CITY PLANNING COMMISSION

APPLICATION: A. Negative Declaration
B. Tentative Map to divide 16.1+ acres into 81 standard single family lots to be called Mesa Grande Unit 8 in the Standard Single Family (R-1) zone

TENTATIVE SUBDIVISION MAP
MESA GRANDE UNIT NO. 8
 City of Sacramento, California

ATTACHMENT A
Discussion of Initial Study for Mesa Grande Unit No. 8
Tentative Map (P89-093)

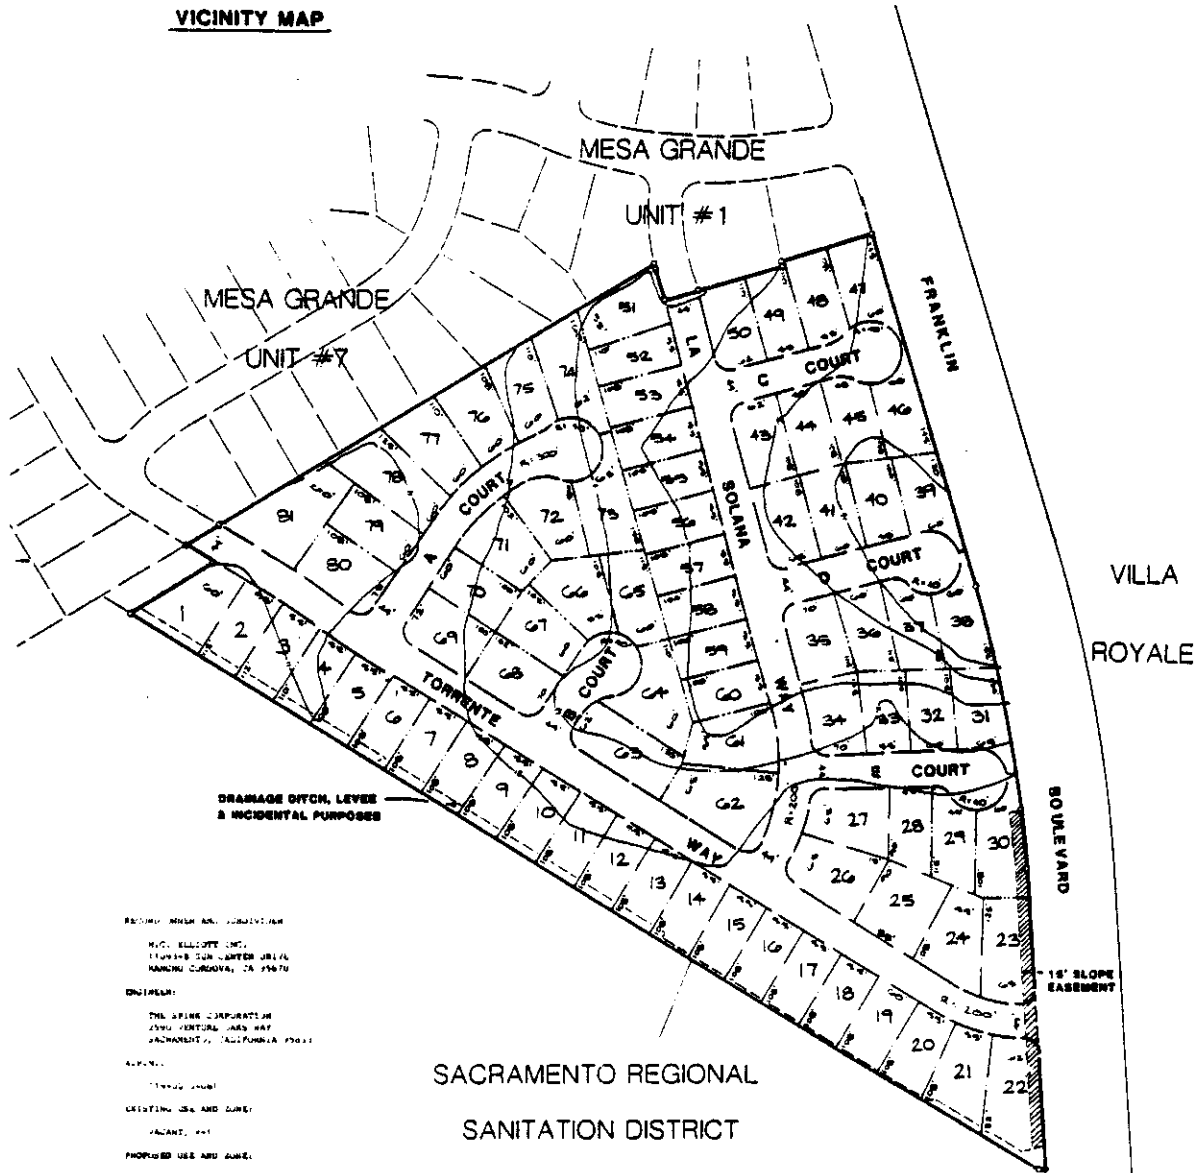
Access to the site will be provided via Valley Hi Drive to the north or through one street off Franklin Boulevard (proposed Torrente Way). City Traffic Engineering has expressed concerns over the future median improvements along Franklin Boulevard north of the Union House Creek bridge and Valley Hi Drive and the location of the entrance off Franklin Boulevard.

The applicant proposes an 81 unit standard single family subdivision in the R-1 Zone. All proposed lots meet the minimum dimensions and lot area requirements in the R-1 Zone. No floor plans or elevations for the dwellings were submitted with the tentative map request. A 15 foot wide slope easement is proposed along lots 22, 23, and 30 for the ramp up to the bridge over Union House Creek. Access to Franklin

Boulevard from Torrente Way may require relocation to the satisfaction of the City Traffic Engineer due to its proximity to Union House Creek or plans for the median along Franklin Boulevard.

Staff and the Subdivision Review Committee have reviewed the proposed design and support the proposed lot layout. The further study of right-of-way for Union House Creek is required by the Public Works Department. The results of the study may require redesign of lots adjacent to Union House Creek.

1. Provide standard subdivision improvements pursuant to Section 40.811 of the City Code (includes Franklin Boulevard frontage);
2. Prepare a sewer and drainage study for the review and approval of the City Engineer;

12. Construct improvements on Franklin Boulevard as per plans on file with the City Public Works Department;
13. Torrente Way to be dedicated to a 50 foot right-of-way between Franklin Boulevard and Solana Way. (Note: Franklin Boulevard will have a center median without a break at Torrente Way.);

15. Right-of-Way Study required for Franklin Boulevard (120 ft R/W);
16. Applicant shall coordinate Franklin Boulevard improvement with Public Works Department - Engineering Division; Median improvements are currently under design;

17. Annex to Regional Sanitation District and pay necessary fees;
18. Right-of-Way study required for Union House Creek. Additional easement dedication may be required to the satisfaction of the Public Works Department Flood Control Division;

Attachment B

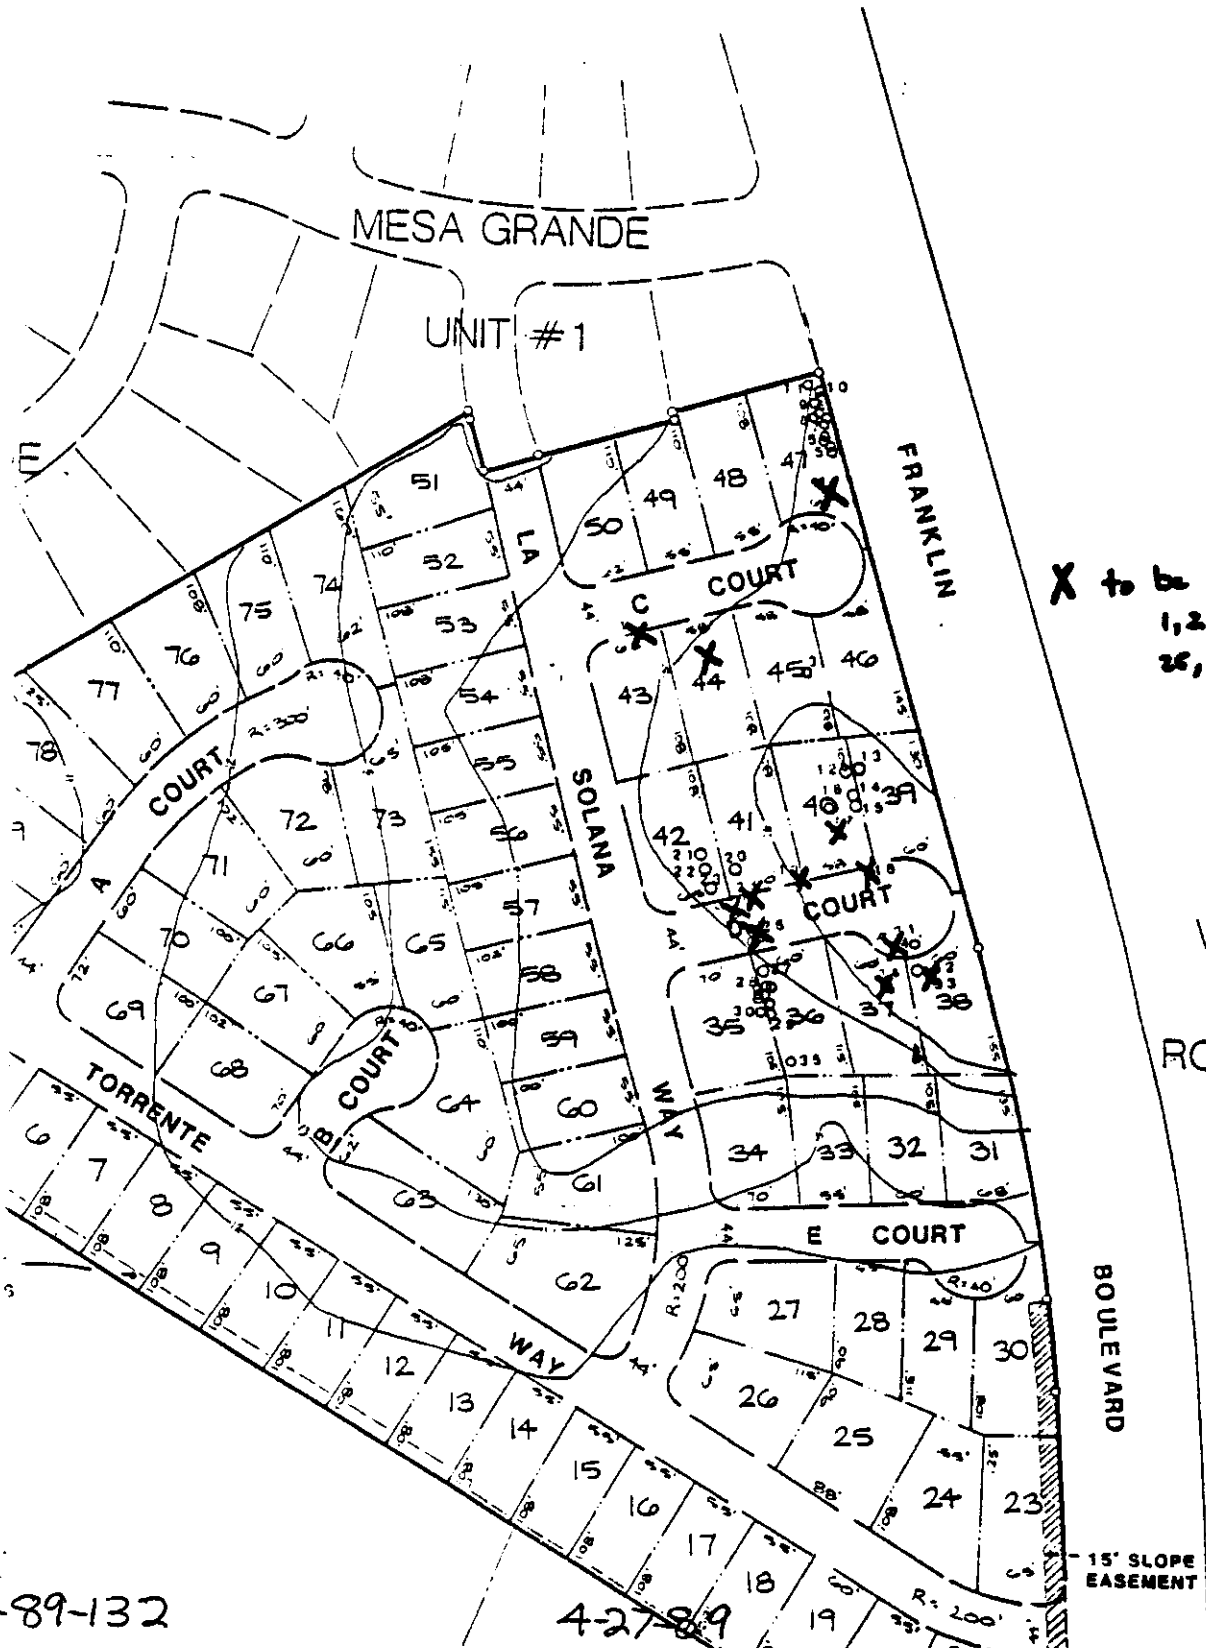
Numerous mature and immature trees are located on the site including Locust, Eucalyptus, Juniper, Ash, and Almond. These trees are located on the northeast quadrant of the site. Many of the trees are located along property lines and can easily be retained while still allowing for development of the lots and circulation system. Mature trees provide habitat for many species of wildlife, even in an urban setting and they enhance the aesthetic value of the site. The following mitigation measure is recommended to retain as many of the existing trees on site as is possible.

1. Only those trees identified as "to be removed", as shown on Attachment B, may be removed. All other trees shall be retained and protected from damage during the construction of the subdivision. The developer agrees to retain those trees identified on Attachment B "to be retained". However, in the event that certain other trees need to be removed in order to comply with other required mitigation measures or conditions of the tentative map, the developer reserves the right to remove those trees.
